Texas Commission on Environmental Quality

Facility Name: City of Del Rio Landfill

Permit or Registration No.: MSW 207C

Re: Response to Technical Notice of Deficiency (NOD)
City of Del Rio
Del Rio, Val Verde County, Texas
Proposed Municipal Solid Waste Permit No: 207C
Tracking No. 29656107; RN102143294/CN600756290
Permit Major Amendment Application

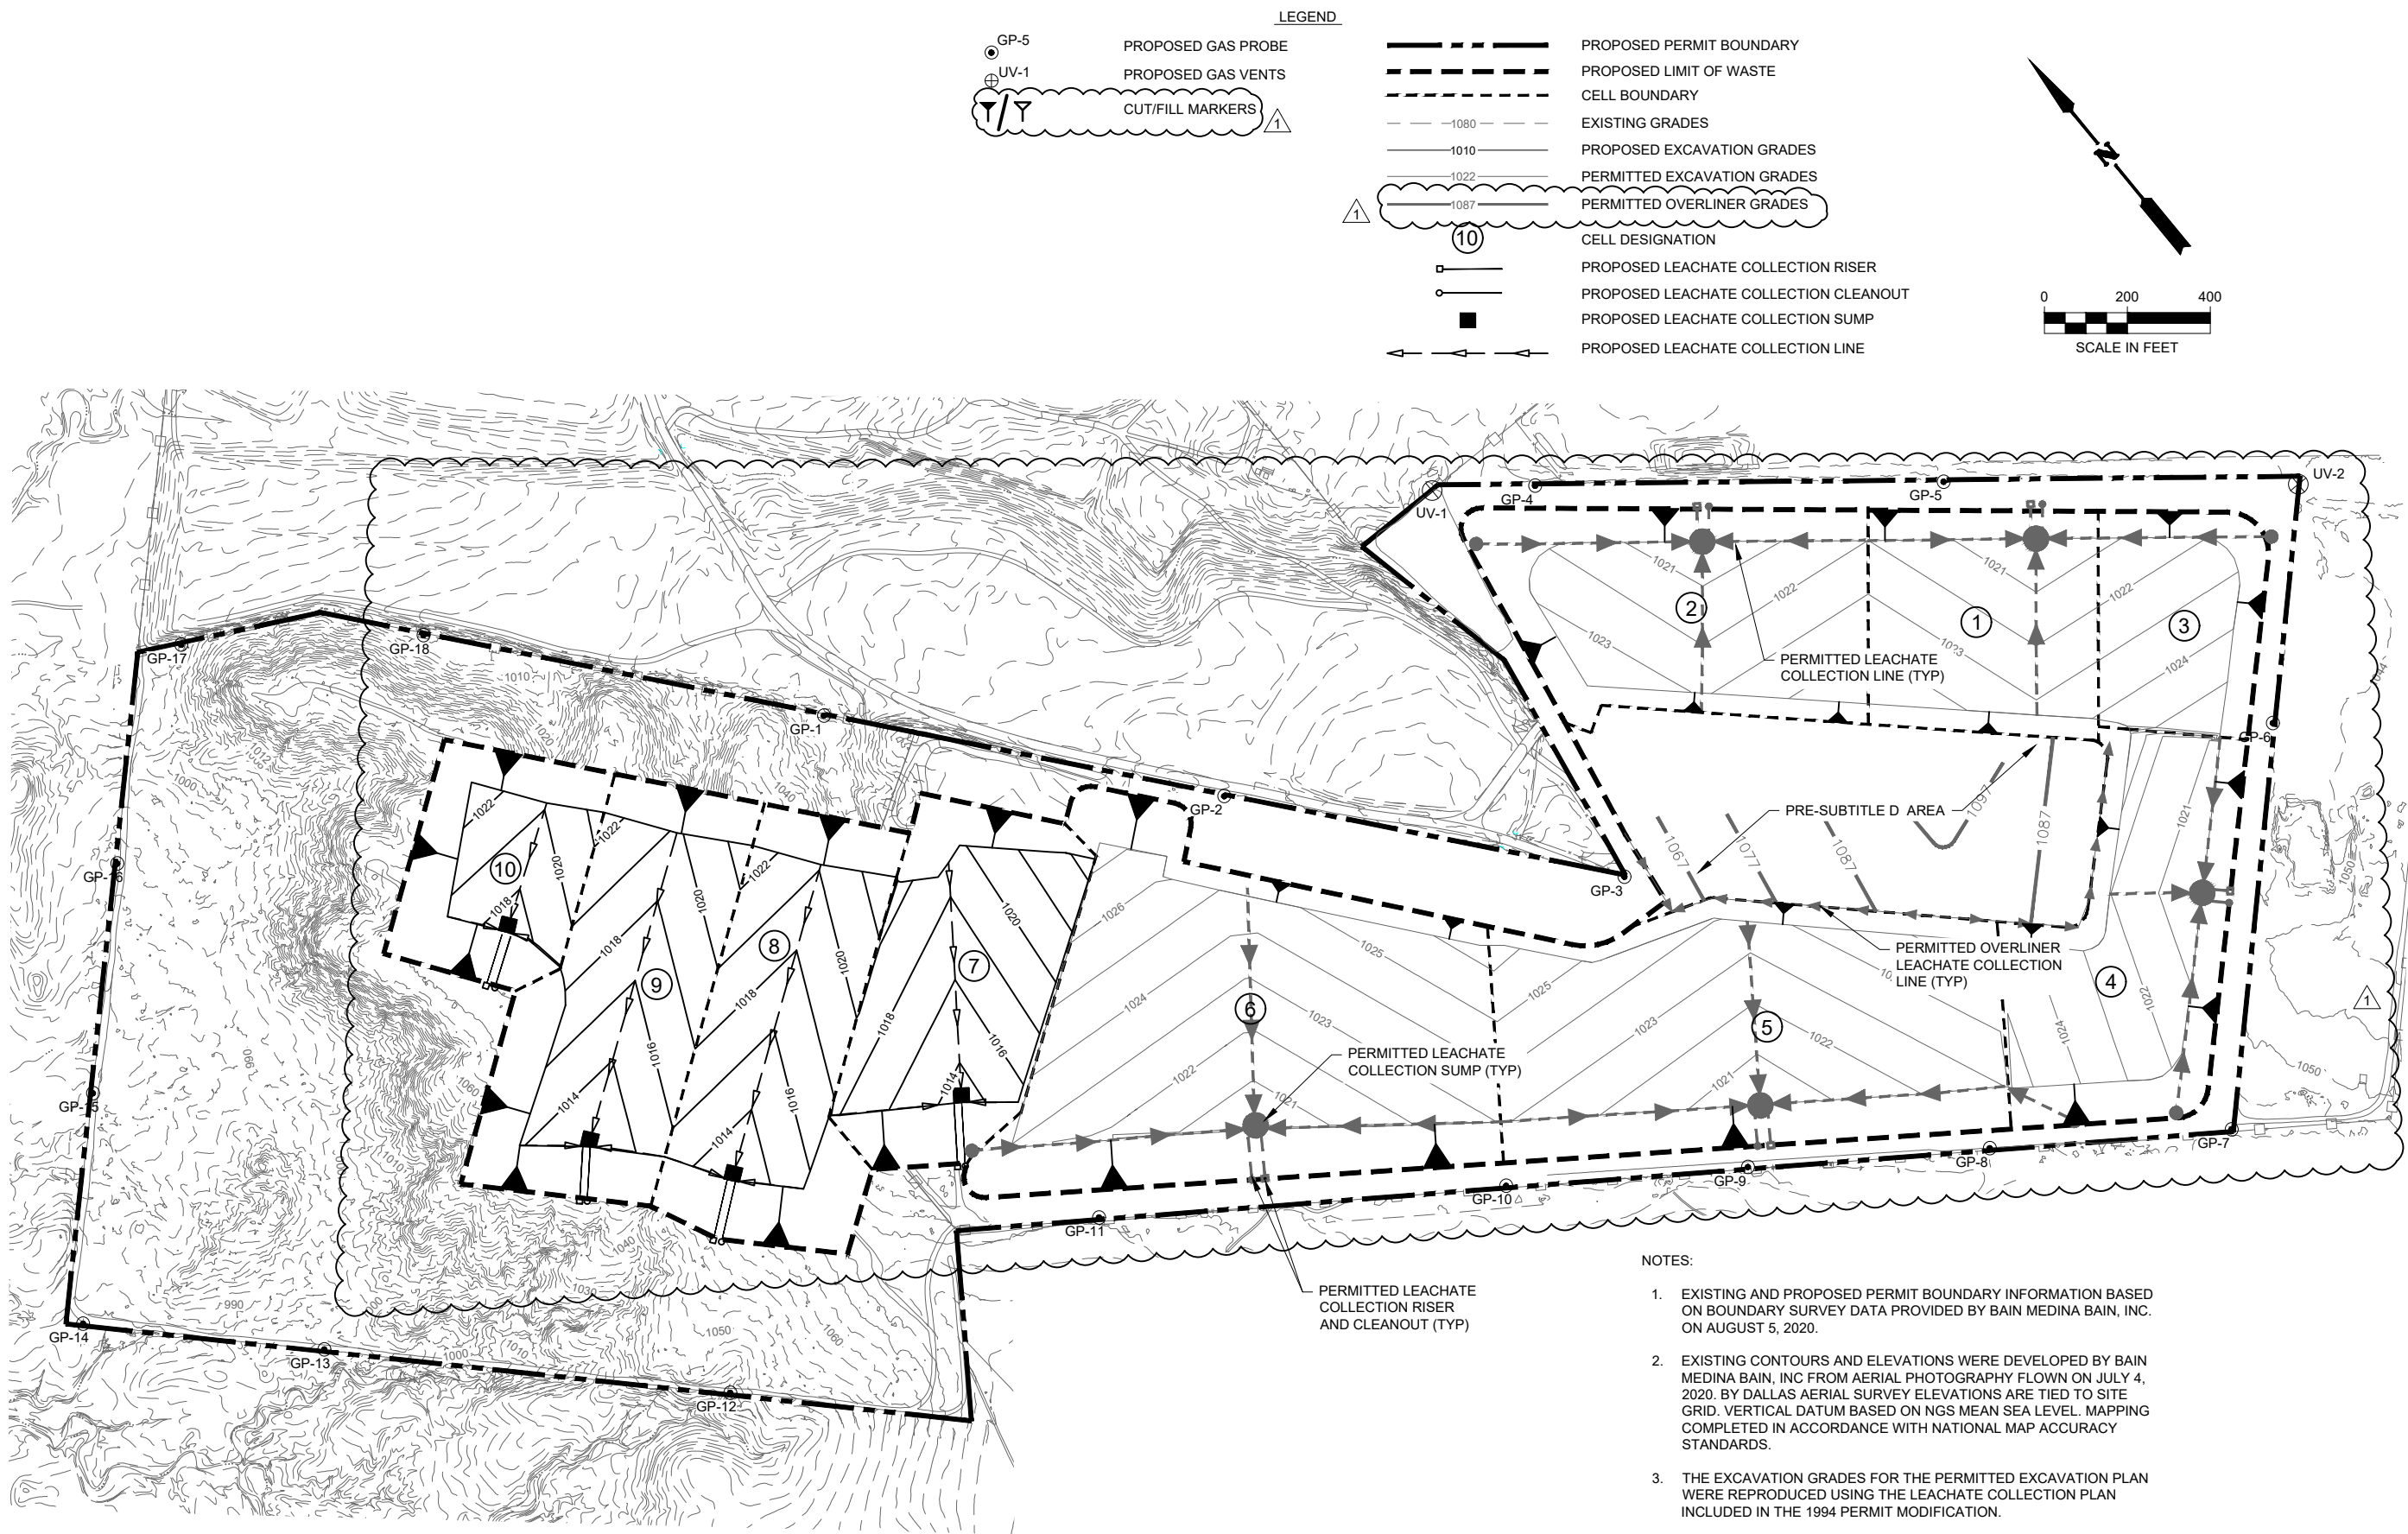
ID	App. Part	App. Section	Location	Citation	Error Type	Deficiency Description/Resolution
T9	25	General	330.57(h)(1)	All drawings	Inconsistent	Comment: Revise Figure I/IIA.2 to provide correct cross-section reference index. Response: The cross-section reference has been updated on I/IIA.2.
T10	27	General	330.57(h)(3)	All drawings	Inconsistent	Comment: a) Revise Figure I/IIA.3 to ensure use of correct cut/fill markers. Revise all relevant drawings in the application to ensure that correct cut/fill markers are used (for example, but not limited to, Figures IIIA-B.2 and IIIC-3.1). It is noted that Figure I/II-2.2 shows a legend for cut/fill markers. b) Revise the table of contents for Appendix IIIC to include Figure IIIC-3.1 Leachate Collection System Plan. Response: a) Figures I/II2.2, I/IIA.3, IIIA-B.2, and IIIC-3.1 have been updated to show the correct cut/fill markers. In addition, the permitted leachate system has been added to these drawings. b) The Table of Contents for Appendix IIIC has been updated to include Figure IIIC-3.1 (page IIIC-11)
